Reference: Gila River Bank Stabilization - Data Collection Memorandum

**Gila River Bank Stabilization Pre-Design Study
Data Collection Report**

COMMENT FORM

Figure No.
Figure 2

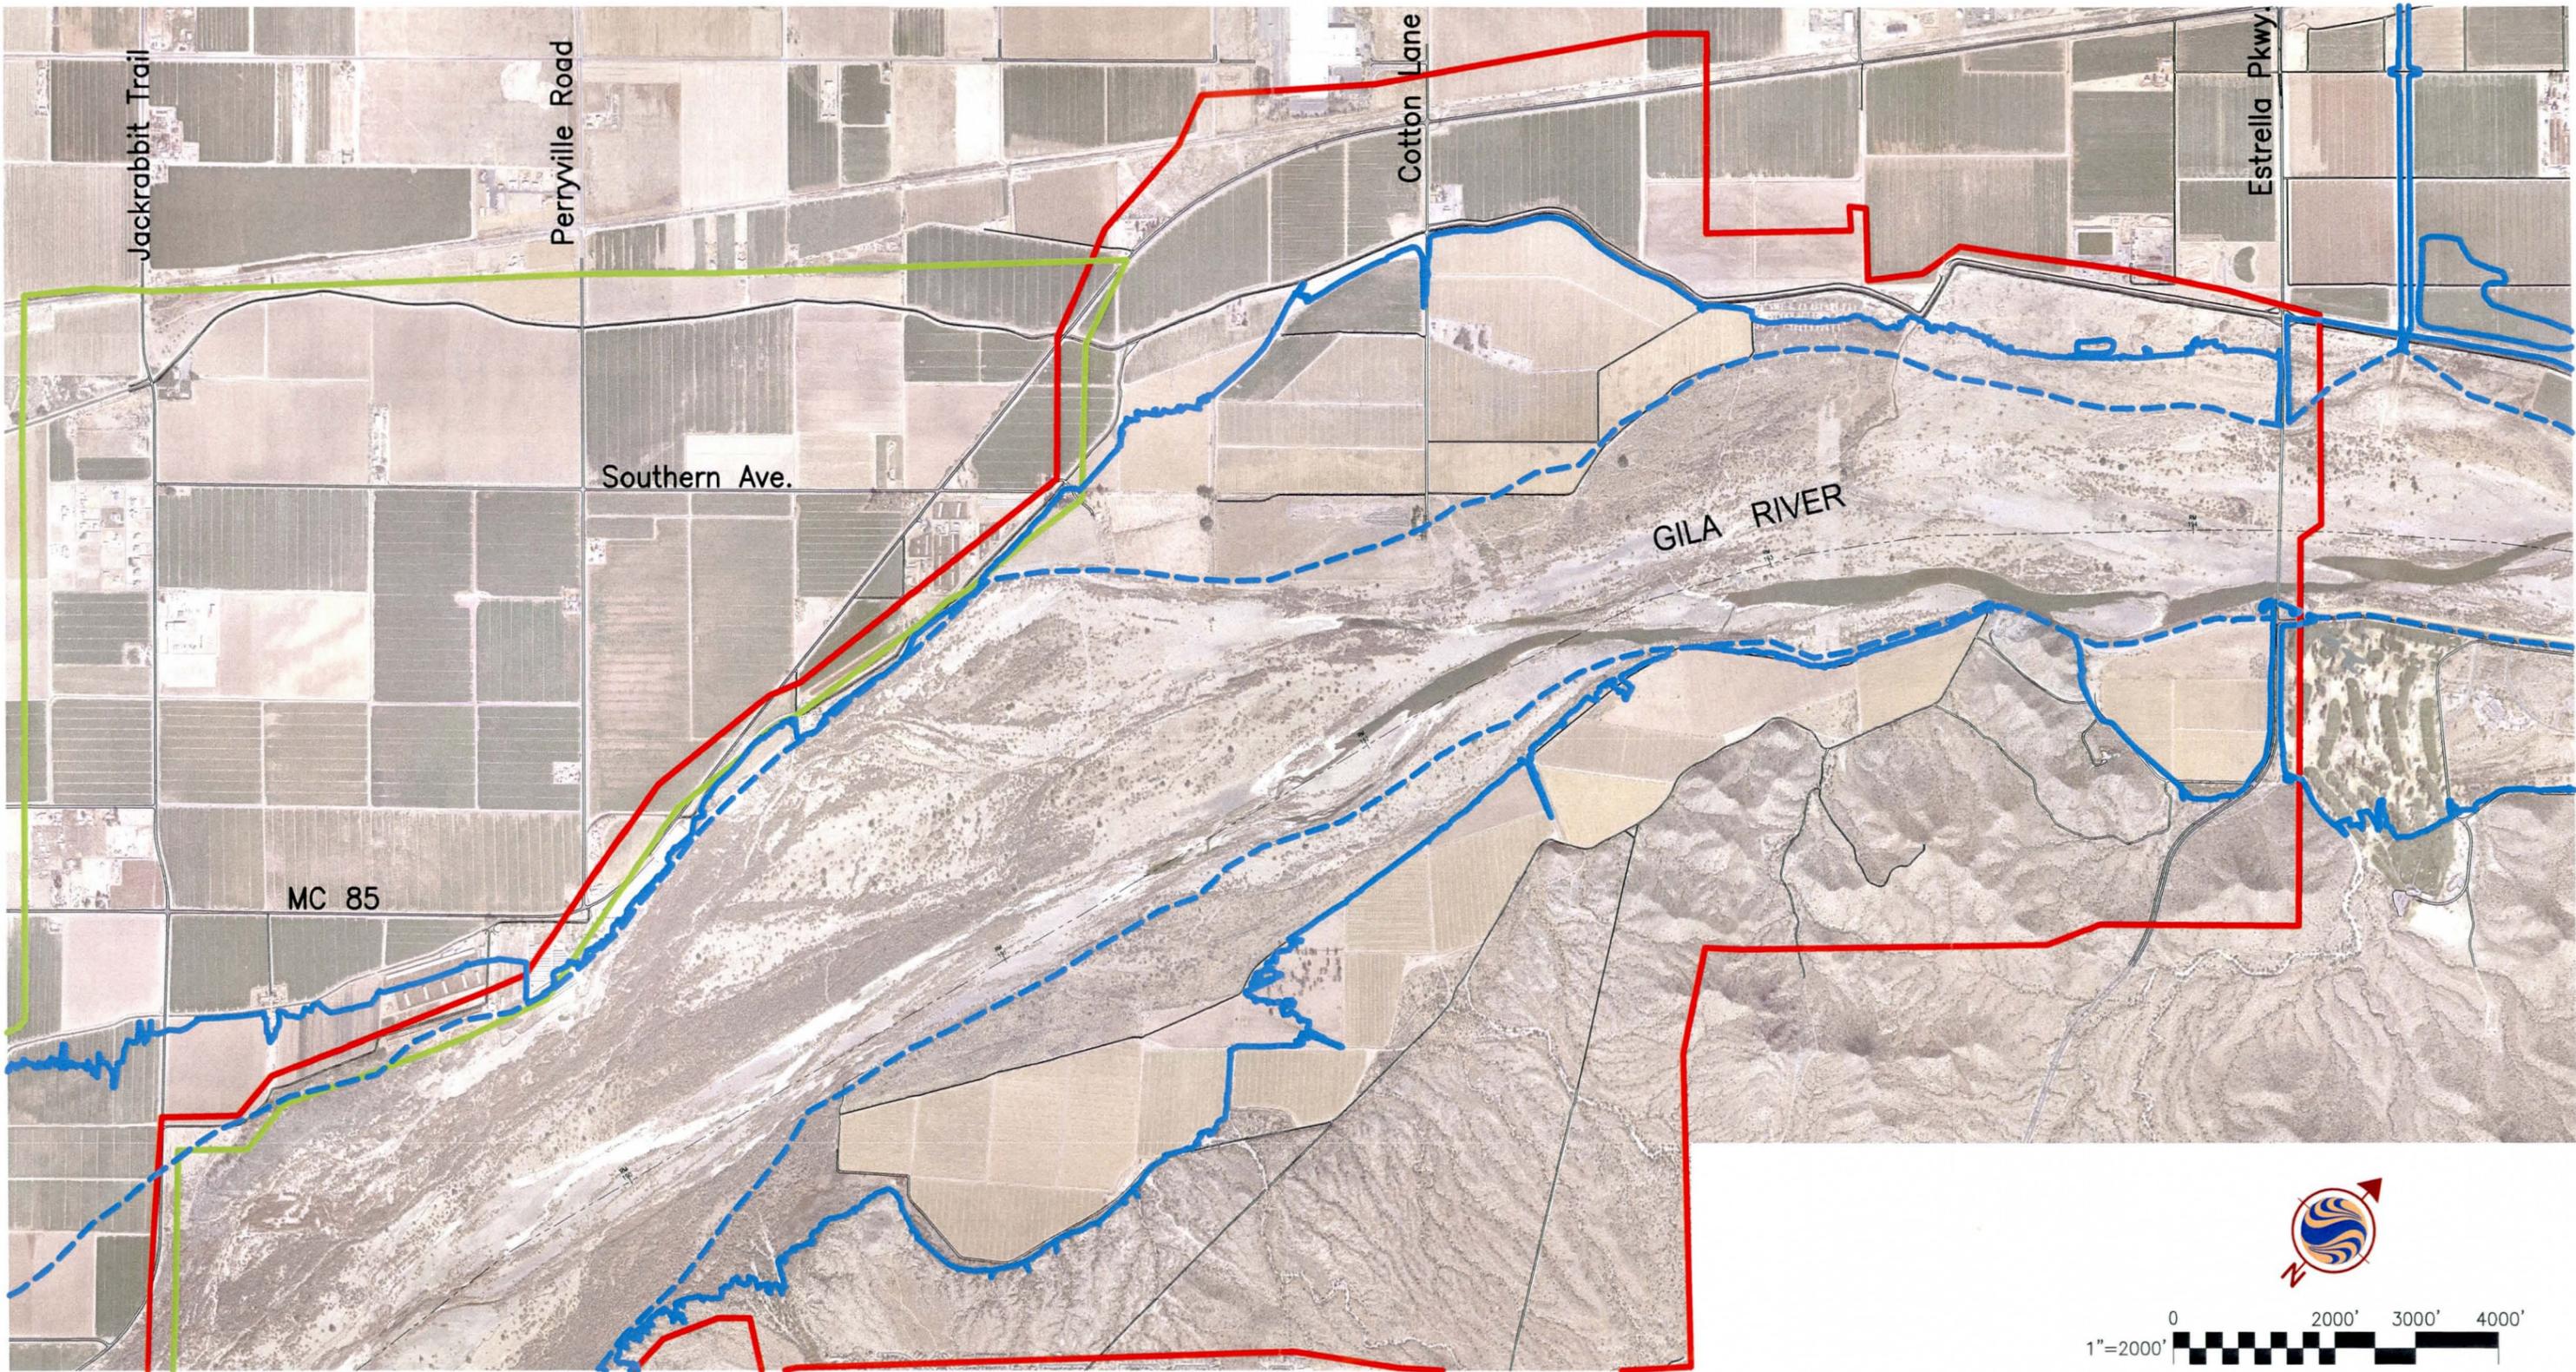
15	Fig. 2	J. Pokorski	On Figure 2, are all of the S&G operations shown actually permitted? If the land is just owned by Dos Rios, don't show it as permitted.	Based on the attribute table provided with the sand and gravel shapefile the operations near the project area are listed as active. This information will be added to the figure and report.
16	2, Land Use Plans	J. Pokorski	Land use is two words. The Goodyear and Buckeye plans should be referred to as "general plans" instead of planning studies.	This change will be made.
17	Fig. 4	J. Pokorski	I'm confused as to how ASM 87-222, 98-4 is depicted. It doesn't appear to be shaded.	The shapefiles for the cultural resource sites include polygons, lines and points. ASM 87-222, 98-4 was provided as part of the line shapefile.
18		J. Pokorski	Should we include a map showing the difference in the floodplains (original v. revised) to illustrate the redelineation?	A figure will be included in the report.
